SECTION 2 Elevations _ Block 01 North-East elevation

FOR FULL SUMMARY OF PROPOSED CHANGES SEE SECTION 1.

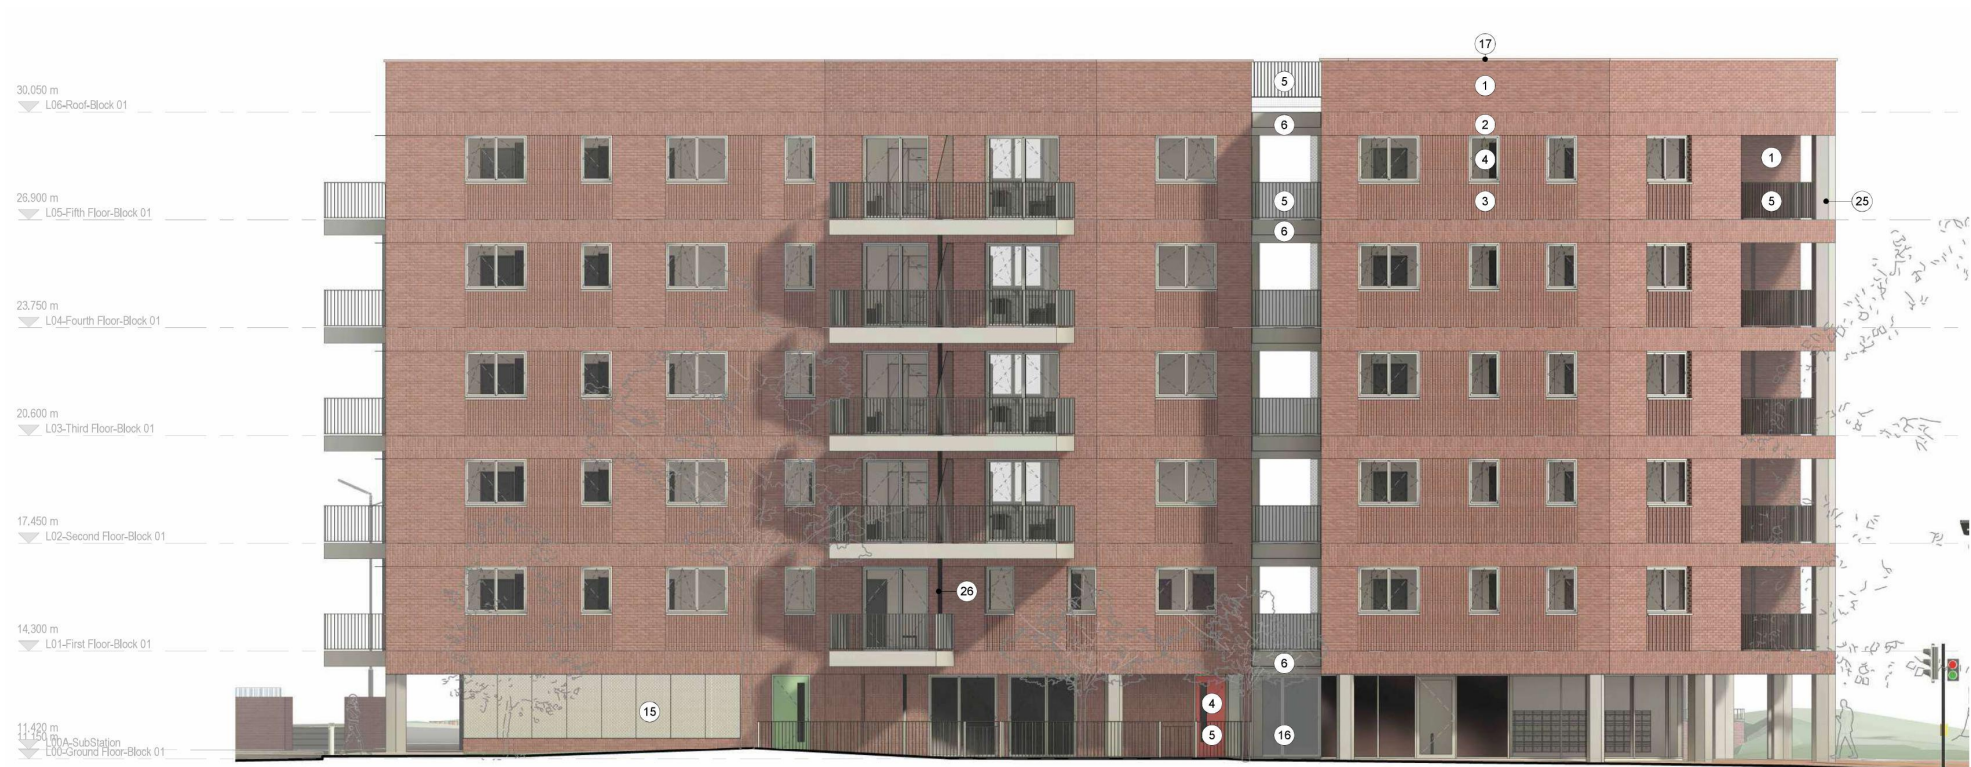
- 6. Lift lobby enclosure.
- 7. Main entrance brick pier for panelling and services installation.
- 8. Ground floor external columns clad in brickwork to match building.
- 9. Aluminium metal cladding to external columns at inset balcony corner and external walkways in upper levels.
- 10/11. Brick coursing at window interfaces.
- 12. Roof bridge removed.
- 15. Canopy over entrance door added.
